Accessibility Design Review Report

Project Title: Concord Mental Health Unit
109 Hospital Road, Concord

Job Number: 23367

Date: 18 October 2023

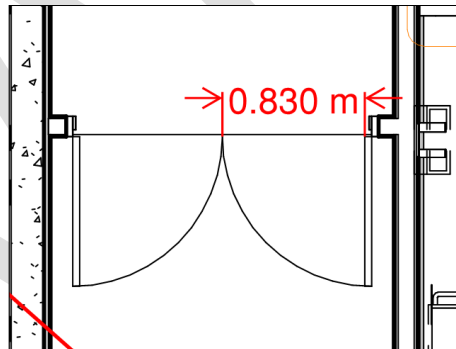
Dual leaf swing doorway along corridors are not afforded with a clear 850mm opening to the active door leaf. (830mm is currently measured)

The door leaf set is to be updated to achieve a min. 850mm clear open to the active door leaf as per AS1428.1-2009. This can be achieved via the use of a cat and kitten door.

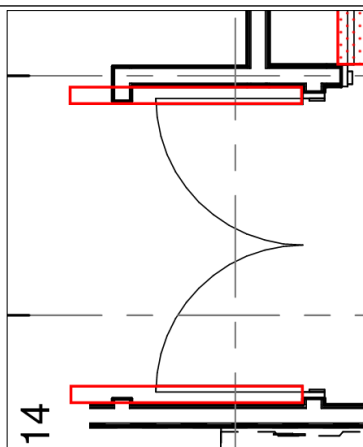
Hinge-side clearance to a number of doorways is obstructed due to the location of a wall build-out surrounding the doorway.

A clear 110mm hinge side clearance is required for a full length of 1450mm as per AS1428.1-2009.

A Performance Solution may be provided where the doorway is either held open or auto operation.

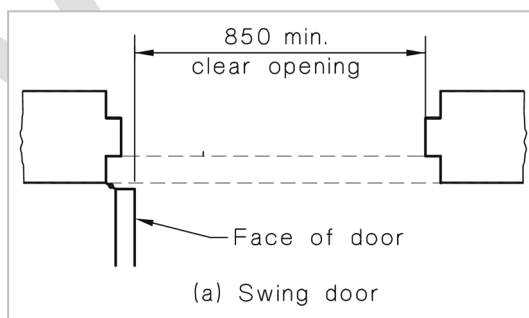
All doorways along an accessway are required to have a clear door opening width no less than 850mm, achieved by the active leaf.

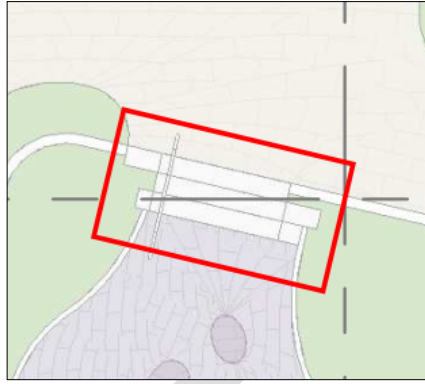
<p><u>Doorway Threshold Ramps</u></p> <p>Where doorway threshold ramps are provided along an accessway, compliance with AS1428.1-2009 is required to be achieved.</p> <p>Doorway leading from Circulation corridor G.C09 is indicated with a doorway threshold ramp.</p> <p>More information in relation to levels, gradient and design of doorway threshold ramp is required.</p> 	CD
<ul style="list-style-type: none"> for a stairway, except a fire-isolated stairway, clause 11 of AS 1428.1; and 	<p>All non-fire-isolated stairways are required to comply with AS1428.1-2009.</p> <p>Detailed drawings of all new communal stairways are to be provided for assessment against the requirements of AS1428.1-2009.</p> <p>The following stairways are required to achieve compliance with AS1428.1-2009:</p> <ul style="list-style-type: none"> - Ground Floor: External (1)  <ul style="list-style-type: none"> - Ground Floor: External (2)

- Ground Floor – Level 2: Stair 1

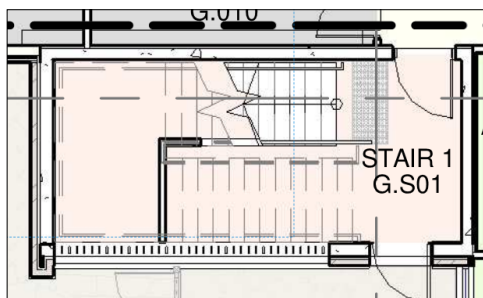
Compliance Departure:

Detail drawings are required for the assessment of the stairways required to be compliant under AS1428.1-2009.

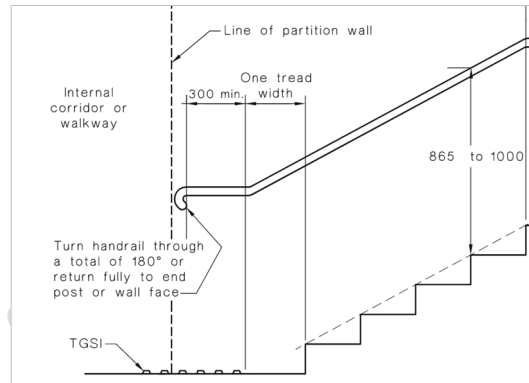
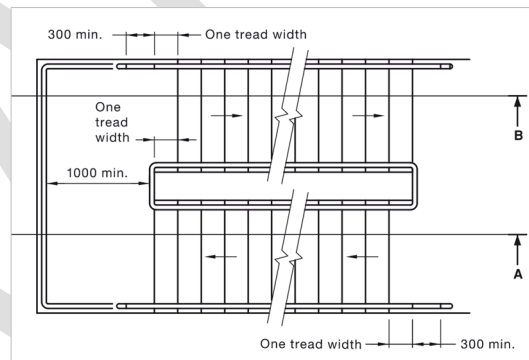
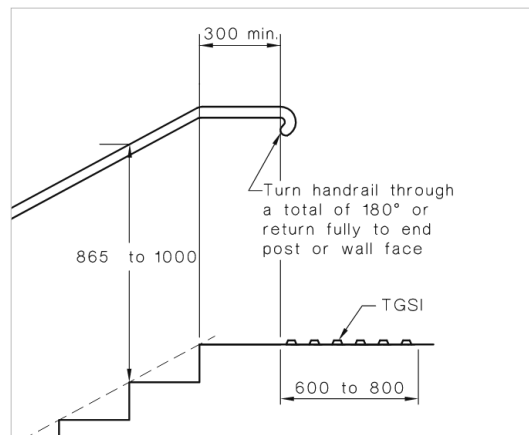
Ensure handrail extensions are provided at top and bottom landings of non-fire isolated stairways and setback/protected by a wall or similar in accordance with AS1428.1-2009 (examples below).

Lower landing 1x tread depth + 300mm horizontal

Mid-landing 1x tread depth

Upper landing 300mm horizontal

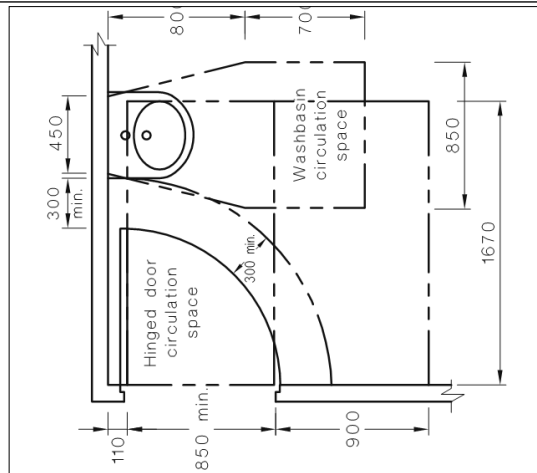
DtS Provision	Comment(s)/Recommendation(s)	Status
<p>In a building required to be accessible:</p> <ul style="list-style-type: none"> • Accessible unisex sanitary compartments must be provided as in accordance with F4D6 (Table F2.4a – 2019), • Accessible unisex showers must be provided in accordance with Table F4D7 (Table F2.4b - 2019), • At each bank of toilets where there is one or more toilets in addition to an accessible unisex sanitary compartment at that bank of toilets, a sanitary compartment suitable for a person with an ambulant disability in accordance with AS 1428.1 must be provided for use by males and females. • An accessible unisex sanitary compartment must contain a closet pan, washbasin, shelf or bench top and adequate disposal of sanitary towels. • Circulation spaces, fixtures and fittings of all accessible sanitary facilities must comply with AS1428.1. • An accessible unisex sanitary facility must be located so that it can be entered without crossing an area reserved for one sex only; and • Where two or more of each type of accessible unisex sanitary facility are provided, the number of left and right handed mirror image facilities must be provided as evenly as possible. 	<p><u>Accessible sanitary compartments</u></p> <p>Plans indicate several new accessible unisex sanitary compartments throughout MHU Building.</p> <p>Accessible bathrooms are indicated at the following location:</p> <ul style="list-style-type: none"> - Ground Floor: G.008 (1970mm X 3300mm). - Level 2: 2.009 (2100mm X 2770mm). <p>The internal compartment size of the accessible bathrooms are capable of complying with AS1428.1-2009.</p> <p><u>Compliance Departure:</u></p> <p>Detailed drawings are to be provided to enable assessment of these facilities in accordance with AS1428.1-2009.</p> <p>Note – A minimum 300mm clearance is required between the door leaf and any part of the HWB:</p> 	CD & DD

Ensure FF&E is installed as per clause 15 of AS1428.1-2009.
